HOUSING DEVELOPMENT AT COSMONA, LOUGHREA, CO. GALWAY

Road Safety Audit Stage 1/2

TOBIN CONSULTING

2.1 **Problem:** Cyclists Entering the Carriageway

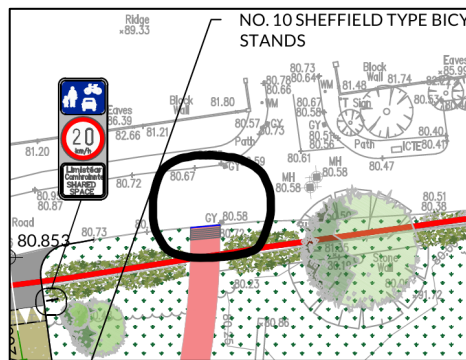
Location: Hazelwood Estate

The design drawings show that the shared footpath/cycletrack ends suddenly at the main access road of the adjacent Hazelwood estate. Cyclists and pedestrians at the end of the track may have limited visibility to the east due to overgrown vegetation. Drivers in the Hazelwood estate may not anticipate cyclists and pedestrians emerging onto the roadway. It is also noted that no dropped kerb and tactile paving is provided opposite the crossing to enable pedestrians cross over to the opposing footpath. This situation could increase the risk of collisions involving pedestrians and cyclists.

Ensure sight lines comply with design standards and that motorists are warned of the presence of pedestrians and cyclists. Provide appropriate dropped kerbs and tactile paving in the footpath opposite.

2.1	Yes	Yes	-----	-----
2.2	Yes	Yes	-----	-----
2.3	No	No	This parking is a proposed access to the existing graveyard to the east of the site – a pedestrian link will instead be provided to the site boundary with the graveyard.	Yes

2.2 **Problem:** Right of Way

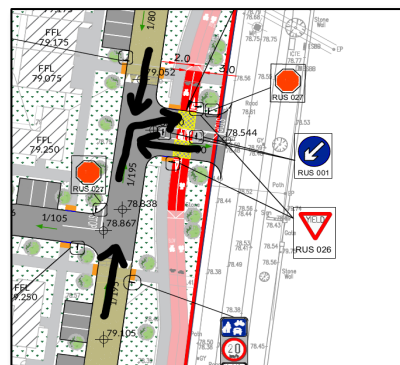
Location: Entrance Avenue

The design drawings indicate a relatively long and straight access road adjacent to the entrance. It is unclear who has right of way at this junction. A lack of clarity may lead to side swipe vehicle collisions at this location.

Ensure adequate guidance is provided to motorists relating to the right of way at this location.

2.5 Problem: Termination for Cyclists from Cycle Track**Location:** Northern & Southern end of the Site

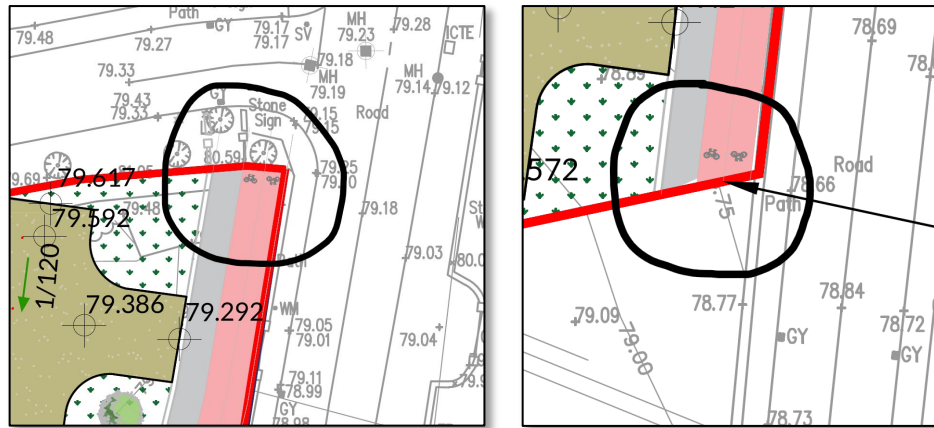
The drawings show a designated cyclist path, but it finishes suddenly at both ends without any details regarding its termination. The absence of features to help cyclists integrate with existing traffic and pedestrian facilities may heighten the risk of collisions involving cyclists

Ensure adequate features are designed and constructed to guide cyclists on and off the cycle track.

2.4	Yes	Yes	-----	-----
2.5	Yes	Yes	-----	-----
2.6	Yes	No	The footpath to the north will be extended to tie create an uncontrolled crossing. Lidl are developing the lands to the south which will provide connectivity to the south	Yes

2.6 Problem: Termination for pedestrians from footpath**Location:** Northern & Southern end of the Site

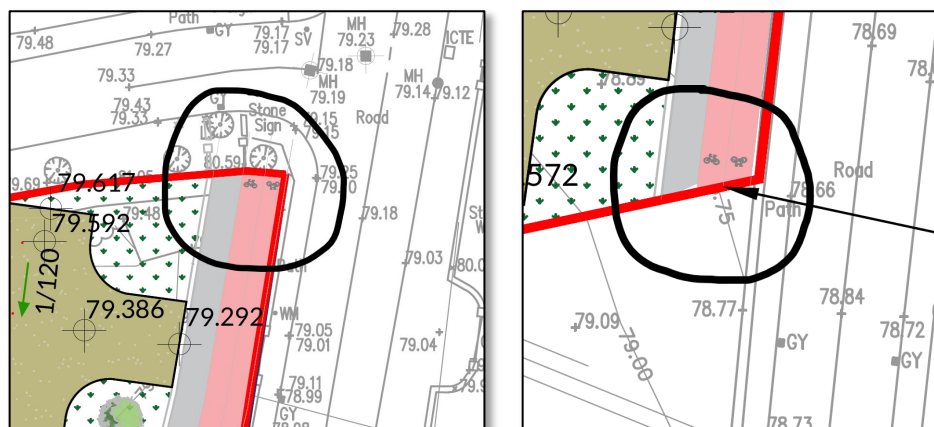
The drawings show a new footpath within the proposed development, but it finishes suddenly at both ends without any details regarding its tie-in to the existing footpaths. The absence of connections to the existing footpaths may increase the risk of collisions involving pedestrians.

Provide appropriate footpath connections to the existing footpaths.

2.7 **Problem:** Visibility Splays

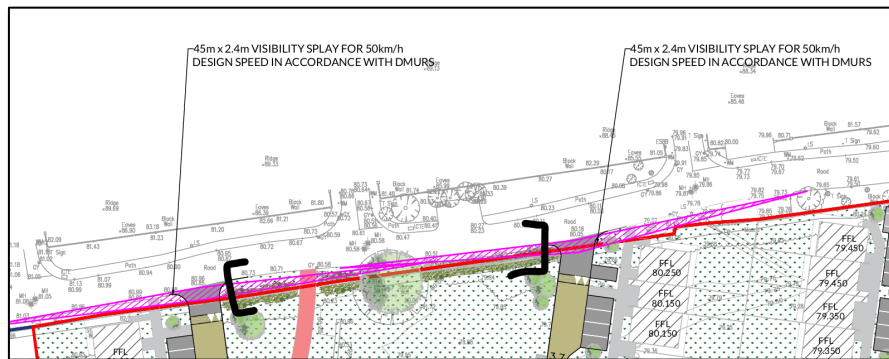
Location: Exiting into Hazelwood Estate

Visibility splays are indicated for both exits into the Hazelwood estate from the Cosmona Development. These visibility splays extend across existing vegetation and shrubbed areas. Over time, excessive growth coupled with a lack of ownership/maintenance may result in visibility splays being reduced. This may contribute to collisions when vehicles are exiting the junctions.

Ensure adequate visibility splays are provided and maintained. Remove trees & shrubbed areas within the extents of the visibility splays.

2.7	Yes	Yes	-----	-----
2.8	Yes	Yes	-----	-----
2.9	Yes	Yes	-----	-----
2.10	Yes	Yes	-----	-----
2.11	Yes	Yes	-----	-----
2.12	Yes	Yes	-----	-----
2.13	Yes	Yes	-----	-----

2.8 **Problem:** Pedestrians Entering the Shared footpath/cycletrack

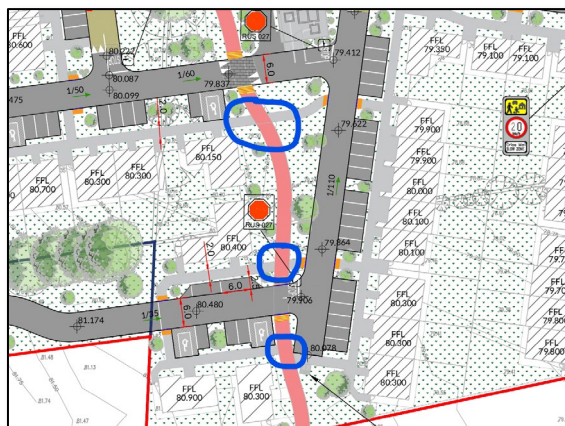
Location: Multiple Locations

Pedestrians may not expect to encounter cyclists on the shared footpath/cycletrack and may not make room for cyclists to pass. This may be a particular issue for visually impaired persons, who may enter the shared surface unbeknown to them, resulting in collisions between cyclists and pedestrians.

Provide appropriate warning for pedestrians where the footpaths meet the shared footpath/cycletrack.

2.9 **Problem:** Inadequate Visibility
Location: Uncontrolled Pedestrian Crossings

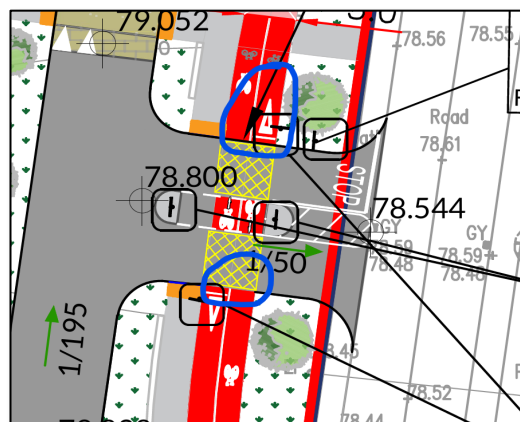
A number of uncontrolled pedestrian crossings are proposed throughout the development. However, it is unclear whether adequate inter-visibility is provided between drivers of vehicles approaching the crossings and pedestrians stopped waiting to cross. Obstructions to intervisibility may include planting, refuse bins and parked vehicles adjacent to pedestrian crossings.

Ensure adequate intervisibility between motorists & pedestrians is provided at uncontrolled crossings.

2.11 **Problem:** Cyclist Speed
Location: Main Entrance Crossing

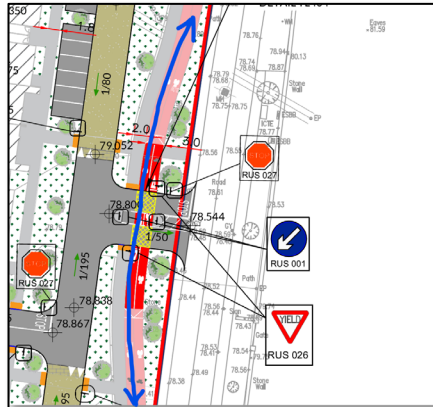
The design drawings indicate a gentle swept path for cyclists as they approach the crossing point. Cyclists approaching at speed may have difficulty stopping to give right of way to vehicles entering/exiting the development. This may result in side-swipe collisions between vehicles and cyclists.

Ensure the approach to the crossing for cyclists incorporates a suitable alignment that promotes cyclists to slow down in advance of the crossing, as outlined in TL404.

2.12 **Problem:** Slow Zone Signage
Location: Throughout

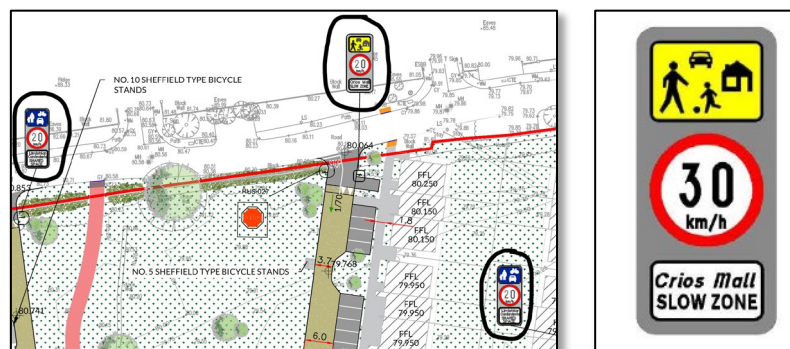
The design drawings indicate Slow Signage and other speed signage throughout. The Traffic Signs Manual indicates that Slow Zone signage for built up areas is 30km/h, however differing speeds are indicated on the design drawings. Confusion regarding the exact speed limit may cause drivers to ignore the actual speed limit, thus increasing the likelihood of accidents and collisions.

Ensure speed limits throughout the development are as per the applicable legislation and the relative design standards.

2.13 Problem: Driver Confusion

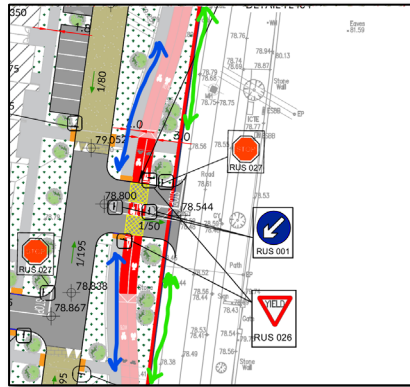
Location: Main Entrance

The design drawings indicate a new pedestrian footpath and crossing within the development. The drawings do not indicate what is proposed for the existing footpath that is between the boundary wall and the R350. Multiple crossing points in close proximity may cause confusion for motorists resulting in an increased likelihood of vehicle & pedestrian collisions.

Remove the existing footpath to limit pedestrians crossing at multiple locations.

2.14 Problem: Pedestrian Delineation

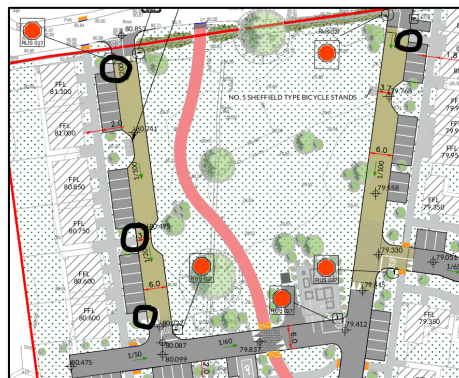
Location: Shared Surfaces

Footpaths and shared surfaces are planned within the development. However, it may not be clear to visually impaired pedestrians where the dedicated footpaths ends, and the shared surfaces begin. Consequently, they might inadvertently step onto the shared surface without realizing it, which could increase the risk of being struck by a passing vehicle.

Provide appropriate tactile warning at the interfaces of footpaths and shared surface.

2.14	Yes	Yes	-----	-----
2.15	No	No	Accessible parking has been located in close proximity to the single storey units where council tenants are most likely to require accessible parking.	Yes

2.15 Problem: Disabled Parking**Location:** Throughout

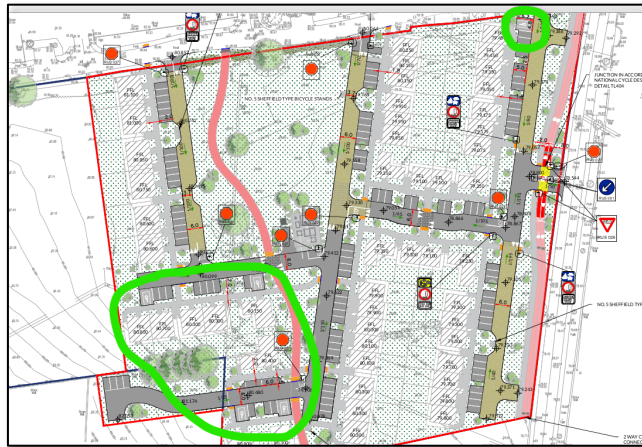
There are five disabled parking spaces, with four located in the southwest corner of the development. However, there are significant areas within the development that lack any disabled parking. Once parked, individuals with disabilities may need to navigate several road crossings to reach their destination, raising the risk of collisions between pedestrians and vehicles

Provide a more even distribution of disabled parking across the site.
